RAPIDPoint® 500 System

Dual LIS Port Invalid Result Transmission

Reason for the Urgent Field Safety Notice

Figure 1. Serial Port Configuration Screen Showing Enabled and Disabled States of the Port

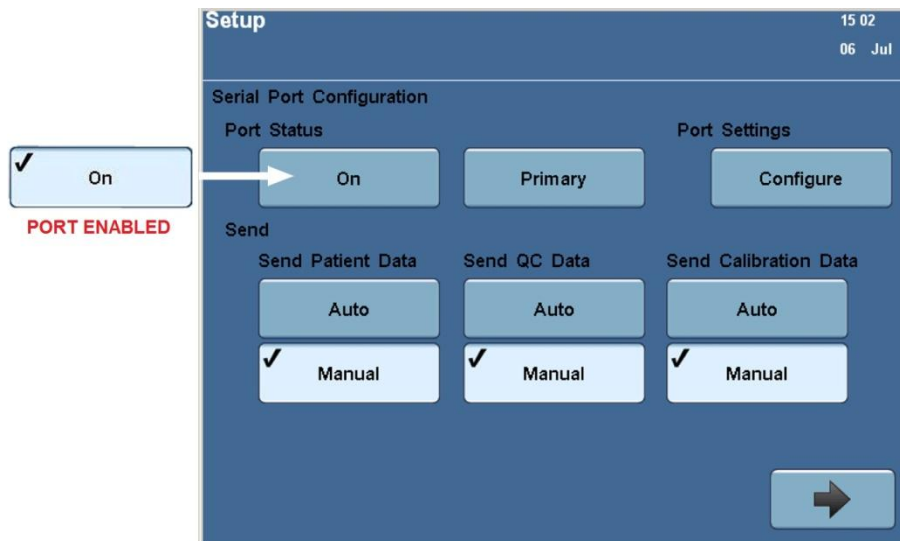
If the system is currently set up with dual LIS transmission enabled, one of the ports (either Serial or Ethernet) needs to be disabled.

To Disable the Serial Port Connection:

1. At the **System** screen, select **Setup**. Enter your password if required.
2. Select **Printer and Devices > Communications > LIS Communications**.
3. Select **Configure** in the **Serial** column.
4. Select **Port Status > On** to disable the Serial port.
The port is disabled when the button is blue and there is no checkmark.
